AVENIR - VISTA

TYPICAL FLOOR PLAN -
LEVELS 9-10

A2.07

LEVEL 9 AND 10 - REVISED
FLOOR PLAN

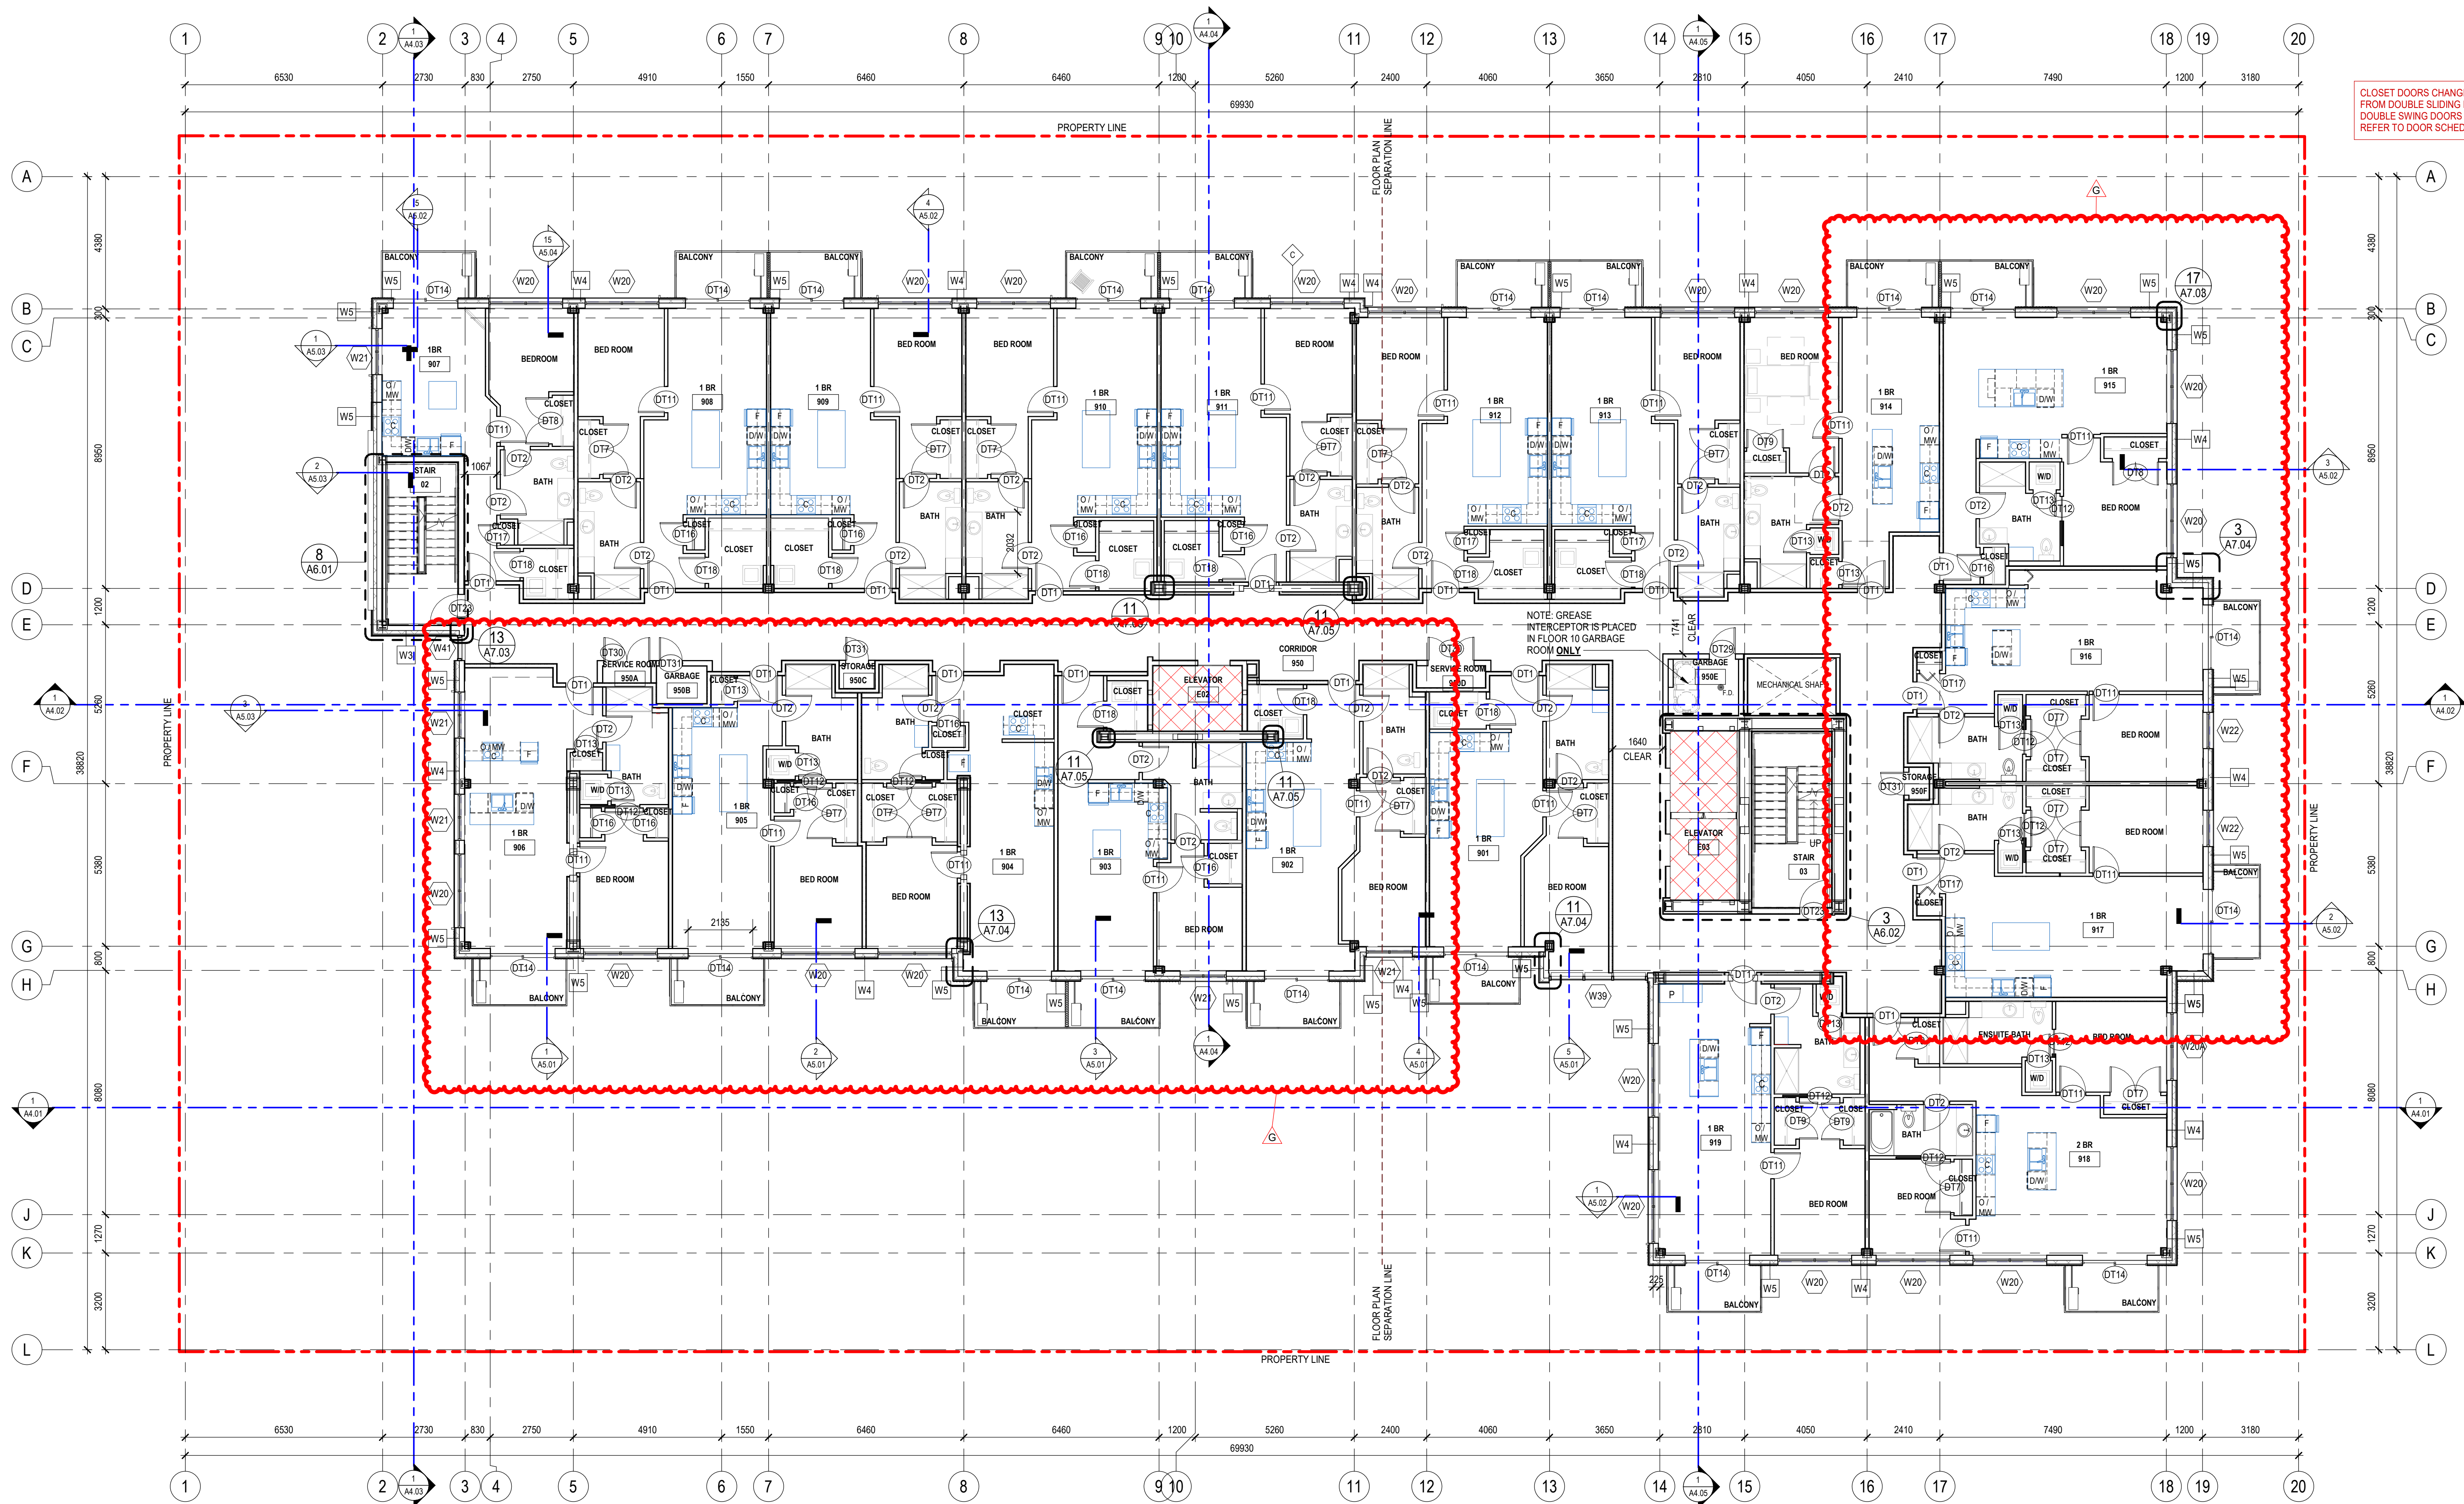
CLOSET DOORS CHANGED
FROM DOUBLE SLIDING DOORS INTO
DOUBLE SWING DOORS
REFER TO DOOR SCHEDULE
